# ISO/IEC JTC 1/SC 25/WG 3 N 754

**DOC TYPE:** Liaison document  
**TITLE:** Letter to the chairman of IEEE 802.3 on a WD for ISO/IEC TR 24750: Guidelines for the support of 10GBASE-T over Copper Balanced Pairs of Class E and Class F as per ISO/IEC 11801(ED.2.0): 2002 and IEEE 802.3an  
**SOURCE:** WG 3 Secretariat  
**PROJECT:** 25.03.02.02-03  
**STATUS:** SC 25/WG 3 N 746 has been distributed for internal review by the WG 2005-03-16, the comments, collated in SC 25/WG 3 N 752, just came in and the resolution process will start in few days. It will include comments from IEEE 802.3 in case such are provided.  
**ACTION ID:** FYI  
**DUE DATE:** n/a  
**REQUESTED ACTION:** For information  
The attached drafts are forwarded to IEEE 802.3 as preliminary information, for consideration and if wished for comment.  
**MEDIUM:** Def  
**No of Pages:** 40 (including cover)

**Letter to the chairman of IEEE 802.3 on a WD for ISO/IEC TR 24750:  
Guidelines for the support of 10GBASE-T over Copper Balanced Pairs of  
Class E and Class F as per ISO/IEC 11801(ED.2.0): 2002 and IEEE 802.3an**

**Assessment of installed balanced cabling channels for the support of 10GBASE-T**

190 **Figure 1 – Example of short channel and long Channel disturbing each other**

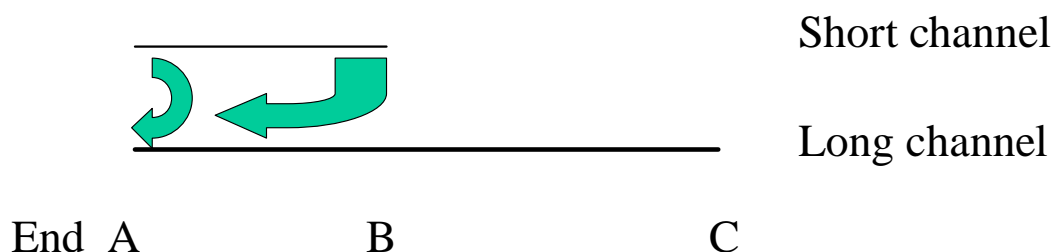
08	184	5	E	UK09	Spelling of "were"	Change to "where"	
08	184	5	E	IL4	Line 184: Misspelling	Change "were" to "where"	
08	188	5	E	UK10	Why is there a reference to ISO/IEC SC25 WG3?	Delete reference or elaborate as an editor's note.	
08	189	5	E	LCG-4	In the Figure 1, need to define the size of the text		
08	194	5	E	UK11	The NOTE is not necessary. PSAELFEXT limits are proposed by 802.3an D2.0 (see AVF15).	Delete NOTE.	
08	194	5	E	IL5	Line 194: SEE IL1	Delete note as DRAFT 2.0 contains the formulae	
09	195	6	T	UK12	195 – 392 Whilst it is the Channel that supports the application, the Channel may not always be in place (even on cabling that has already been installed). It may only be possible to test a Permanent Link. As in the current ISO/IEC 11801:2002, we should the option to "conform" against Permanent Link "requirements". This will also maintain harmonisation with the current TIA TSB-155 draft document.	Include Permanent Link" requirements" for all parameters. Use the information contained in 3N731 (or a later contribution if available) as a starting point.
